Re: Revisions to Heritage Impact Assessment and Conservation Plan for 58-60 Ellen Street East & 115 Lancaster Street East, City of Kitchener.

ARA Project #: 2021-0338-03 (HR-384-2021)

Table 1: Heritage Impact Assessment – Comments to be Addressed

Figure 1: Proposed Site Plan
(John MacDonald Architect)

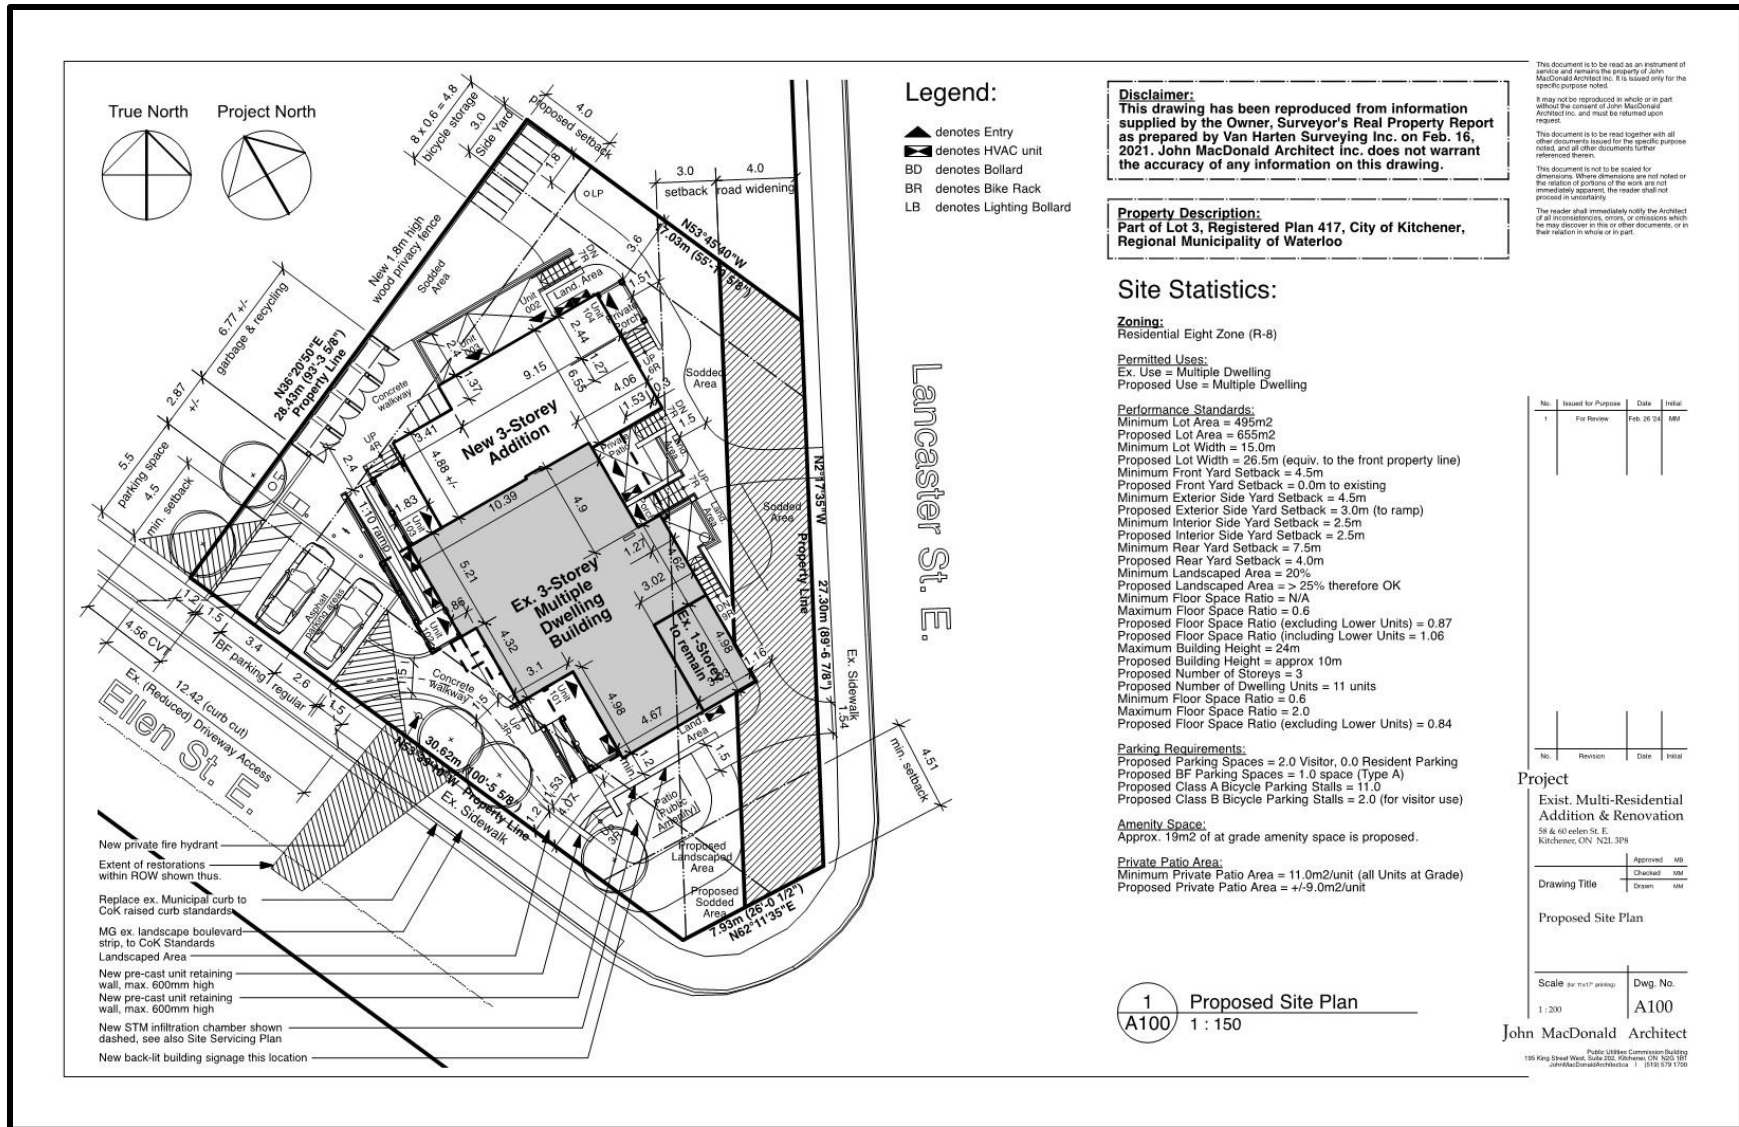
Staff Comment: This section could require updating based on present garbage collections plans.	presented in the Conditional Approval of Site Plan Application. See Section 3.0.
---	--

The site plan of the revised design (see Figure 1) outlines that two asphalt parking spaces will be located in the northwest corner of the property, using the existing driveway access and curb cut along Ellen Street East. Garbage and recycling storage is proposed along the northern property boundary as well as a bicycle storage area for eight bicycles. These amenities are proposed to be buffered from the neighbouring properties by a 1.8-meter-high wood privacy fence. The east elevation along Lancaster Street East is primarily a sodded area with concrete pathways to access the unit entrances. The south elevation includes a patio/public amenity area, landscaping and sodded area where Ellen Street and Lancaster Street East intersect. Lastly, the west elevation includes a concrete walkway, landscaping features, new fire hydrant, retaining wall, and backlit building signage and multiple trees. Figure 2 shows the overall massing of the proposed addition.

**Figure 4: Proposed Site Plan- South Elevation
 (John MacDonald Architect)**

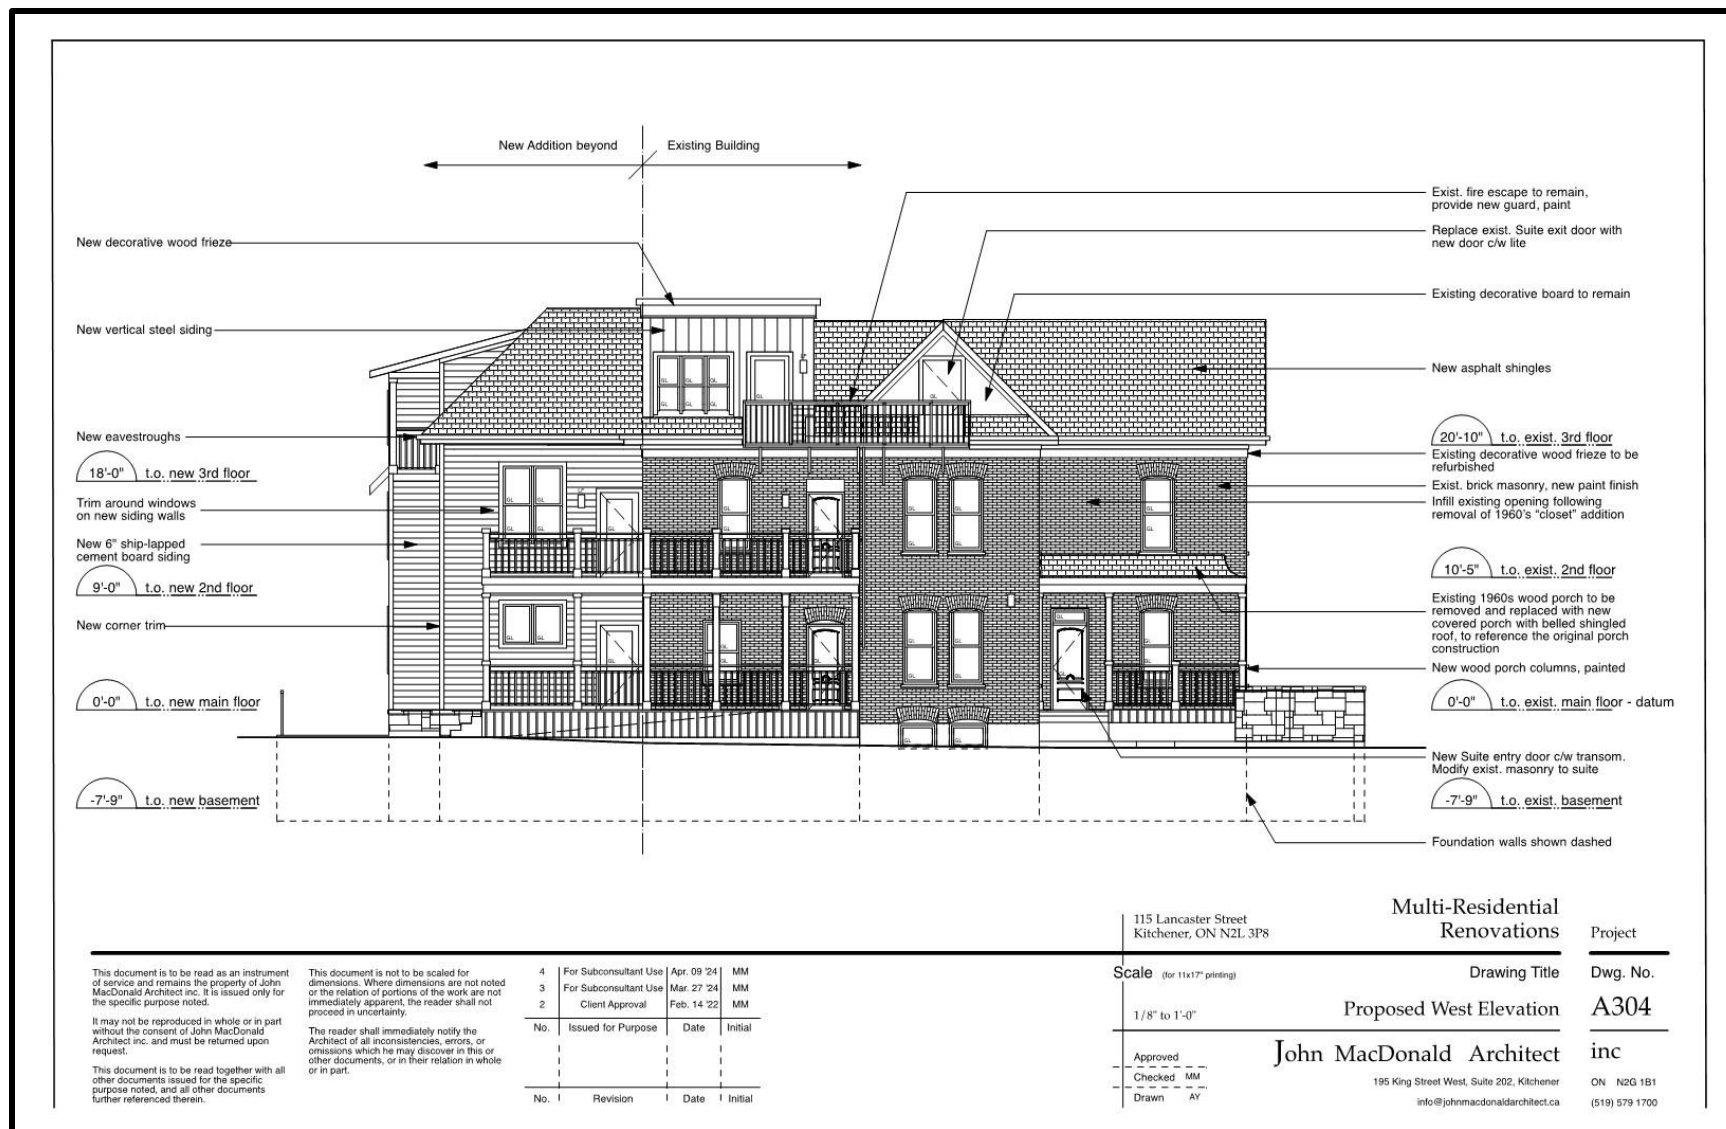
<p>HIA Page No: 51/52 HIA Section: Analysis of Potential Impacts (HIA Table 7, Guideline 5 - Recommended Practices and Guidelines Considered from Section 6.4 Alterations of the Civic Centre Neighbourhood HCD Plan) Staff Comment: <i>The HIA should provide commentary on the impact and mitigative measures of removing of the existing wooden sash window and infilling of door and window openings. It is not sufficient to just comment that they are being removed.</i></p>	<p>ARA has provided further details related to the removal of the existing wooden sash windows and any infilling of doors and window openings in the design presented in the Conditional Approval of Site Plan Application. See Section 3.0.</p> <p>The chart discussing this guideline has been updated accordingly to address this comment. See Section 4.0, Table 5.</p>
<p>HIA Page No: 52 HIA Section: Analysis of Potential Impacts (HIA Table 7, Guideline 6 - Recommended Practices and Guidelines Considered from Section 6.4 Alterations of the Civic Centre Neighbourhood HCD Plan) Staff Comment: <i>The proposed replacement of doors and windows will not be the same material. The windows are proposed to be</i></p>	<p>ARA has provided further details related to the removal of the existing wooden sash windows and the rationale for this decision alongside a comparative cost analysis of retaining the existing windows. See Section 3.0.</p>

With respect to the façade (south elevation), specific changes to the elevation are outlined in Figure 4 and include:

- Retaining and restoring the multi-paned, coloured glass sash windows located on the second and third storey which were identified as heritage attributes contributing to the building’s Queen Anne architectural style.
- Enlarging an existing, but modified window opening on the first floor to reinstate the original masonry opening.

Figure 5: Proposed Site Plan- East Elevation
 (John MacDonald Architect)

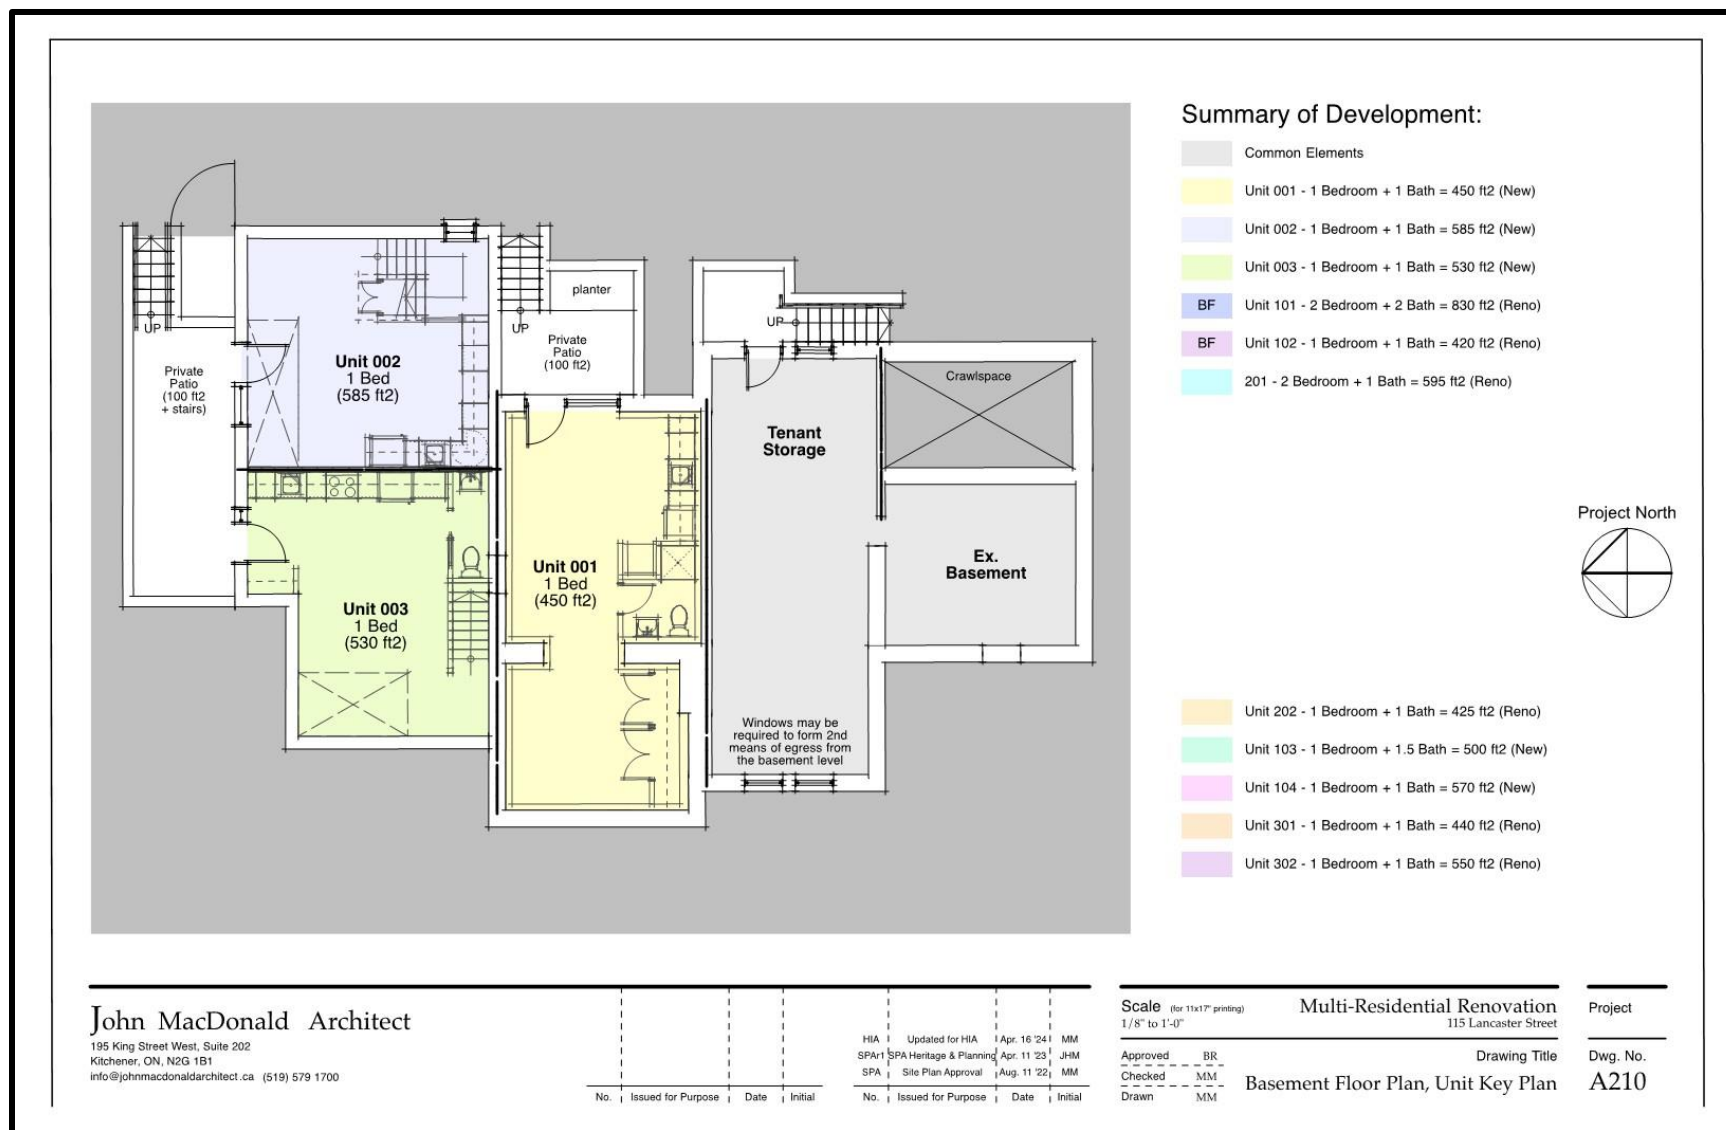
<p>HIA Page No: 52 HIA Section: Analysis of Potential Impacts (HIA Table 8, Guideline 2 - Guidelines Considered from Section 6.9.3. Area Specific – Ellen Street East of the Civic Centre) Staff Comment: <i>The height and roofline of the proposed building is in keeping with the original building, but the proposed design has to stepback. The HIA should include commentary on how this part of the policy is not being satisfied and suggest mitigation measures.</i></p>	<p>ARA has provided further details related to how the built form was considered in the design presented in the Conditional Approval of Site Plan Application. See Section 3.0.</p> <p>The chart discussing this guideline has been updated accordingly to address this comment. See Section 4.0, Table 6.</p>
<p>HIA Page No: 53 HIA Section: Analysis of Potential Impacts (HIA Table 8, Guideline 5 - Guidelines Considered from Section 6.9.3. Area Specific – Ellen Street East of the Civic Centre Neighbourhood HCD Plan) Staff Comment: <i>This would need to be updated to reflect the new proposed place for garbage.</i></p>	<p>ARA has provided a revised description of the proposed development to reflect the design presented in the Conditional Approval of Site Plan Application. See Section 3.0.</p> <p>The chart discussing this guideline has been updated accordingly to address this comment. See Section 4.0, Table 6.</p>

With respect to the east elevation, specific changes to the elevation are outlined in Figure 5 and include:

- Construction of an Arriscraft cut stone wall and guardrails to frame the entrances to the proposed basement units.
- Construction of a shed roof dormer on the third storey containing a rectangular window opening composed of three windows. The dormer walls will be clad in cement board shingles (James Hardie colour “Aged Pewter”) that will match the three-storey addition on the north elevation. The dormer roof will be clad in asphalt shingles matching the rest of the roof cladding.
